INDESIT company

IDL75EU.2

F032627

Notices

N1045072FIG1

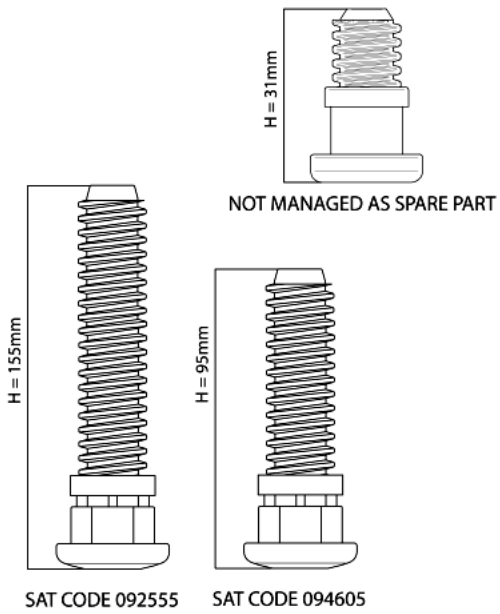
N1045072: Introduction of fixed rear foot H=31mm on free-standing models.

From serial no. 40218.0001, free-standing dishwashers affected by this modification have been equipped with new fixed rear feet (H=31mm).
The new foot replaces the adjustable one (H=155mm) Service code 092555; on the EVO3 range with TurboDry the new foot replaces the adjustable foot (H=95mm) Service code 094605.
The Spare Part Warehouse will continue to manage only 155mm and 95mm adjustable feet as they are interchangeable with the fixed 31mm foot.
The three feet are shown in illustration N1045072FIG1.

N1045083FIG1

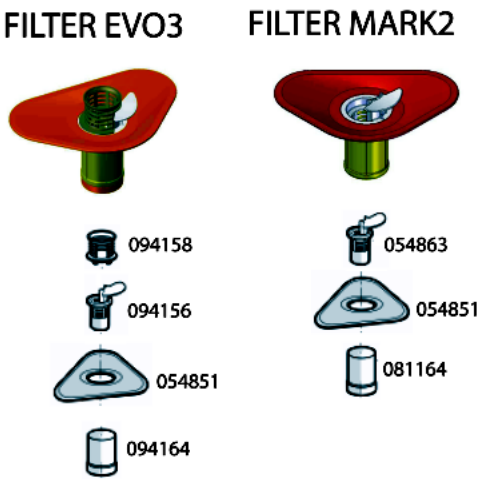
n1045083: Modification of filters on EVO3 60 cm dishwashers

All dishwasher models affected by this modification have been equipped with the items listed below, in order to solve the drain pump clooging problem.

The modification has been introduced progressively, starting from serial no. 40516.0001.

Introduction of:
Cylindrical plastic filter code 081164
Central filter code 054863

Elimination of:
Cylindrical plastic filter code 094164
Central filter code 094156
Central filter grid code 094158

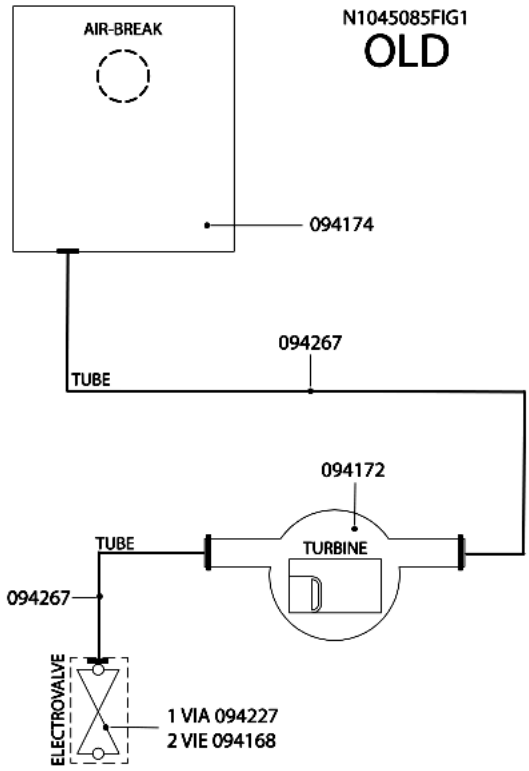
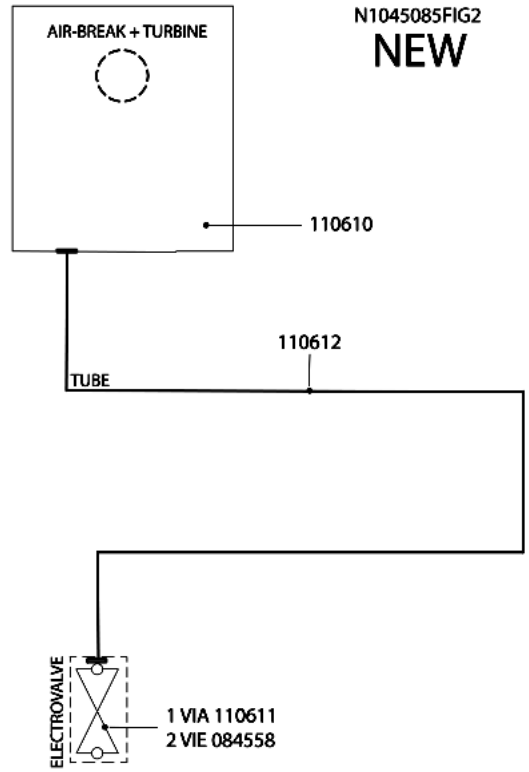
n1045085: Introduction of new litre counter turbine integrated on air-break.

All dishwashers affected by this note have been equipped with a new litre counter turbine on the air-break.
Picture N1045085FIG1 illustrates the premodification structure, picture N1045085FIG2 the new structure.

AIR-BREAK:
new 110610;
premodification 094174;
the new item features a new integrated litre counter turbine and its water supply hose has a smaller diameter.

LITRE COUNTER TURBINE code 094172 has been eliminated.

SOLENOID VALVES:
new:
1-WAY code 110611;
2-WAY code 084558(Rohs 143737);
premodification:
1-WAY code 094227;
2-WAY code 094168;
the new solenoid valves have a smaller diameter drain hose fitting.

HOSES:
new solenoid valve hose/air-break code 110612;
premodification turbine hose/air-break code 094267;
premodification solenoid valve hose/air-break code 094267;
the new hose has a smaller internal diameter.

WIRING:
the litre counter turbine connecting cable is longer, but since the connector is the same, the new item can be used in place of the premodification one.
